HISTORIC AND DESIGN REVIEW COMMISSION

HDRC CASE NO: 2016-193
ADDRESS: 407 DEVINE ST
LEGAL DESCRIPTION: NCB 2957 BLK 1 LOT 2 W 10 FT OF 3
ZONING: R5 H
CITY COUNCIL DIST.: 1
DISTRICT: Lavaca Historic District
APPLICANT: Adriene Wilson
OWNER: Adriene Wilson
TYPE OF WORK: Fencing
REQUEST:

The applicant is requesting a Certificate of Appropriateness for approval to install a wrought iron fence in the front yard at 407 Devine.

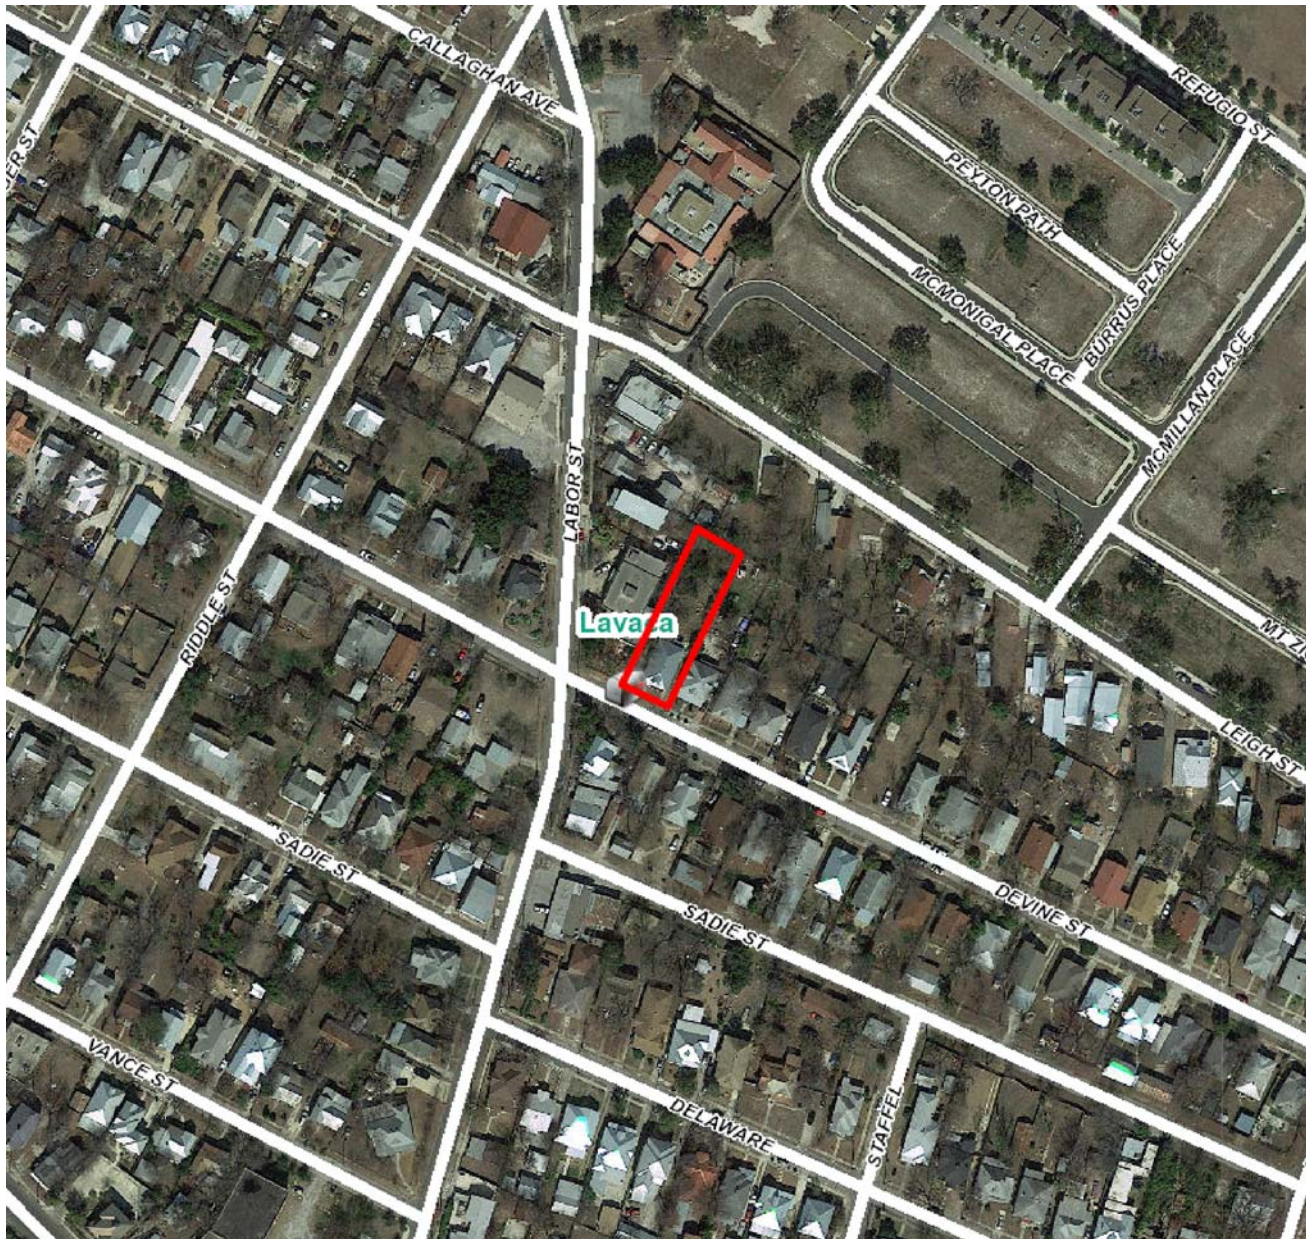
- d. The property to the immediate west of 407 Devine features a fence that runs parallel to the sidewalk at the public right of way. Staff finds that the applicant's proposed fence should share the same setback as the adjacent property's fence.

- i. That the proposed gates not exceed four feet in height.
- ii. That the applicant's fence share the same setback as the fence on the property to the immediate west.
